Pre-Buy Inspection Report N

CESSNA 172H SN: Tach: 3139.3 ATT: 4536.6*

This report represents the findings of a pre-buy inspection performed at KAJO on 12/22/2020. Information was obtained through a physical inspection of the aircraft and logbooks provided by the owner.

Aileron Cable Rubbing on Flap Push Rod

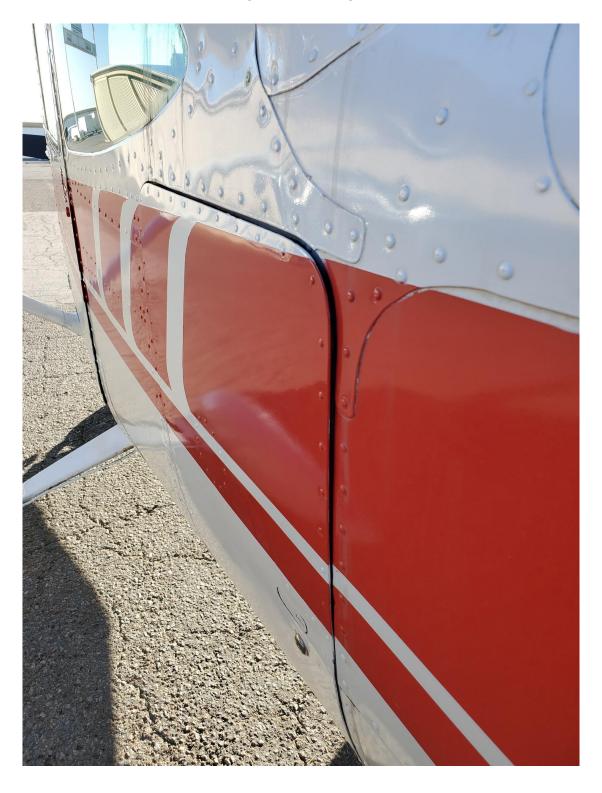
- -Left, upper inboard and upper outboard flap rollers are worn beyond limits
- -Left aileron cable rubbing on top of rod end of flap push rod
- -Cargo door misaligned with airframe
